DOVER SCHOOL DISTRICT	JOINT BUILDING COMMITTEE – DOVER HIGH SCHOOL AND REGIONAL CTC MEETING NOTICE	
	Meeting Type:	**Regular Meeting**
	Meeting Location:	**Superintendent's Conference Rm, McConnell Center**
	Meeting Date:	**Tuesday, July 23, 2019**
	Meeting Time:	**4:30 P.M.**

Joint Building Committee
Dover High School and Regional CTC
Minutes

Re: Change Request Proposal – 190305
Auto Collision Wash Bay

Re: Change Request Proposal – 190361
Softball Fields Fence Revisions

THIS DRAWING FOR DIMENSIONS ONLY.
PR 067

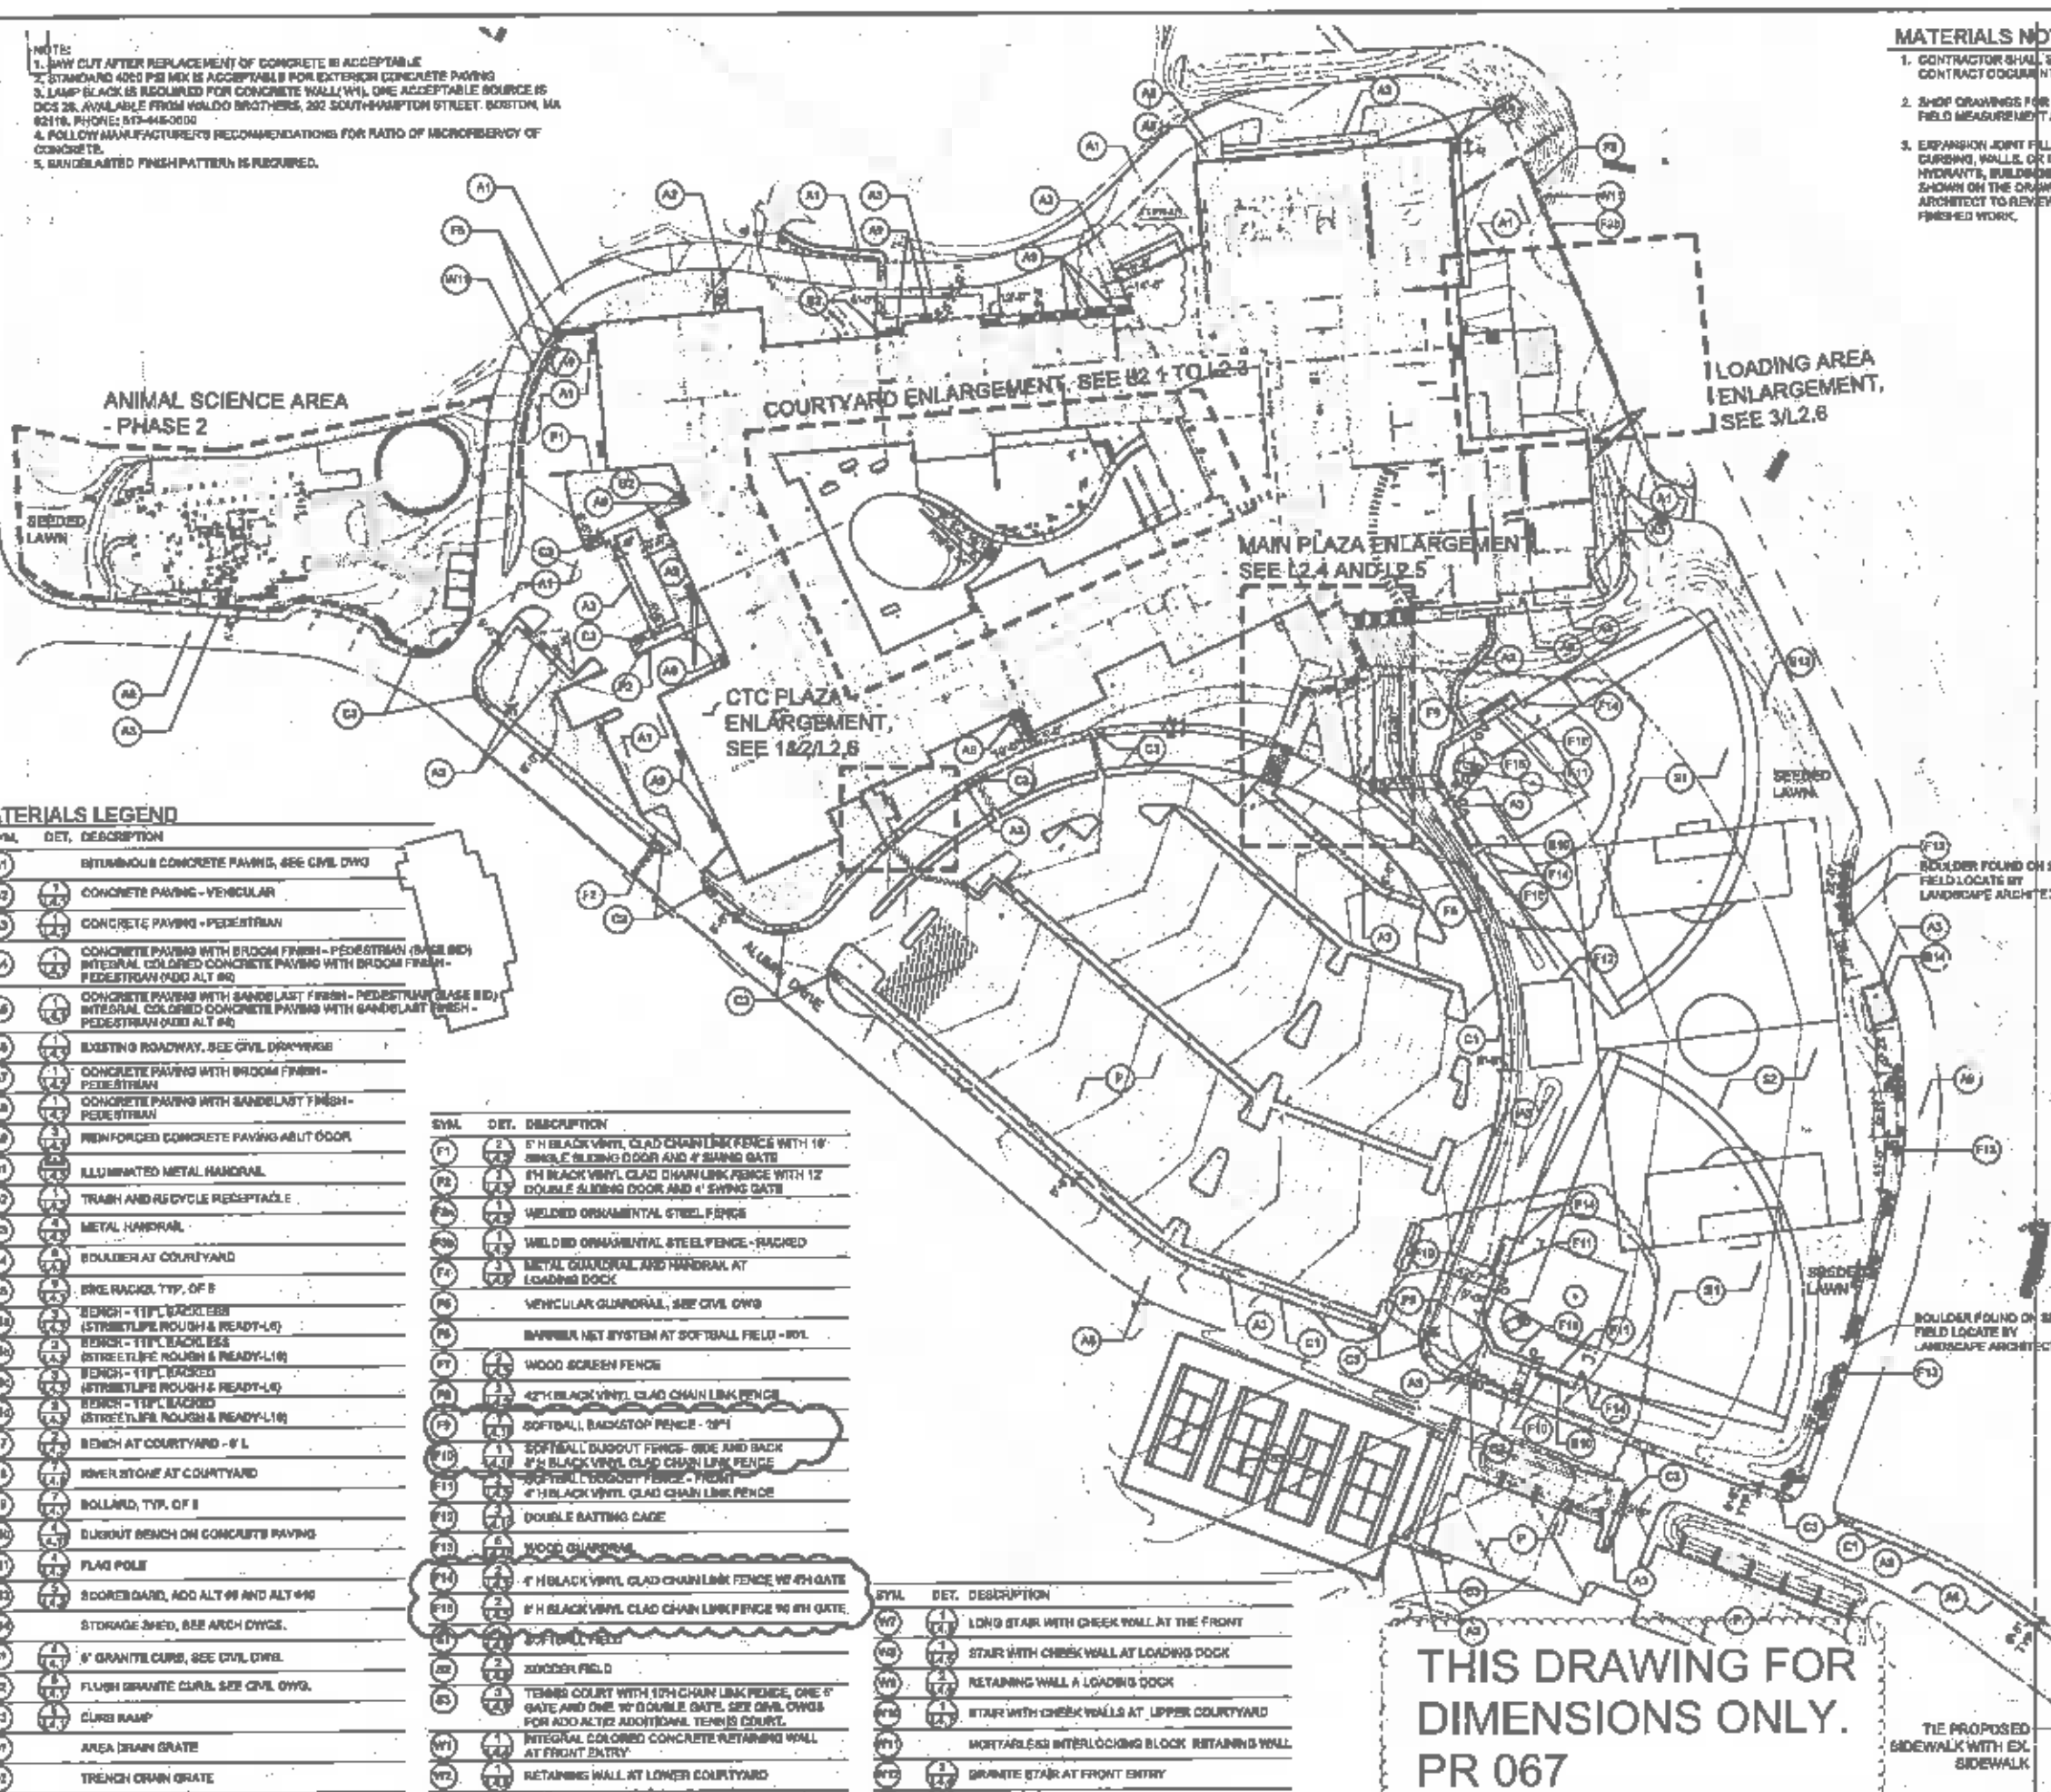
Please provide a cost for the revisions as identified on the attached Drawings.
Field relocation does not require revised grading.
Revisions include:

1. Relocating the fields
2. Increasing the height of the backstops
3. Increasing the height of the fence between the backstop and dugouts.
4. Adding (2) 4' high gates at each field.
5. Provide dugouts similar to the ones built by Norman Vetter Foundations at the Roger Allen Park in Rochester (30'x8' pad). Provide 8' fence between 4' openings on each side. Provide credit for specified dugout and fencing.

Dugout Pad Size Change

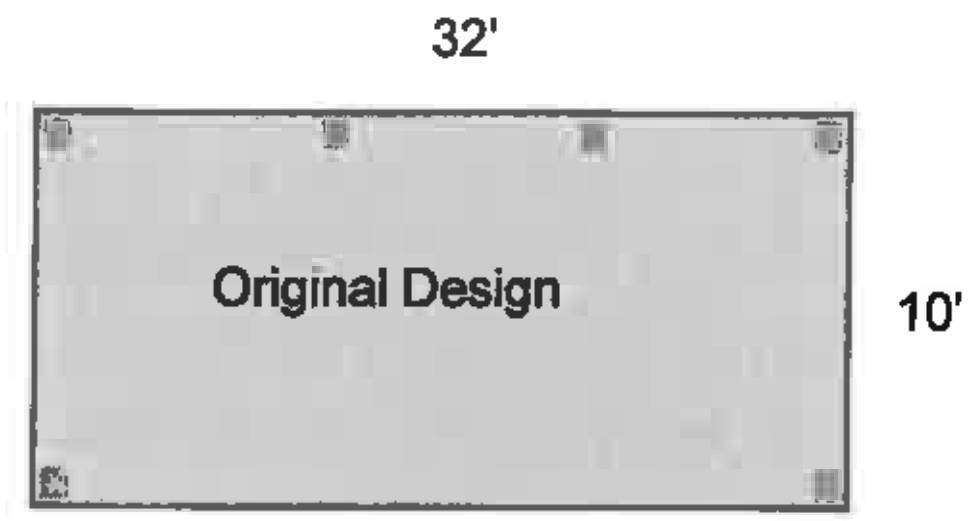
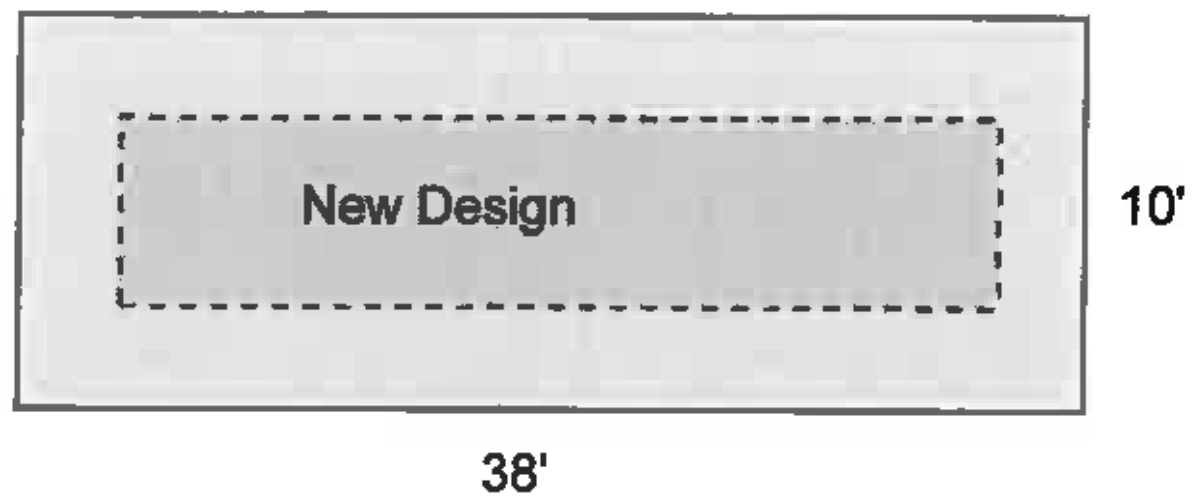
4" Thick Concrete Pad

4" Thick Concrete Pad with 24" x 12" deep haunch
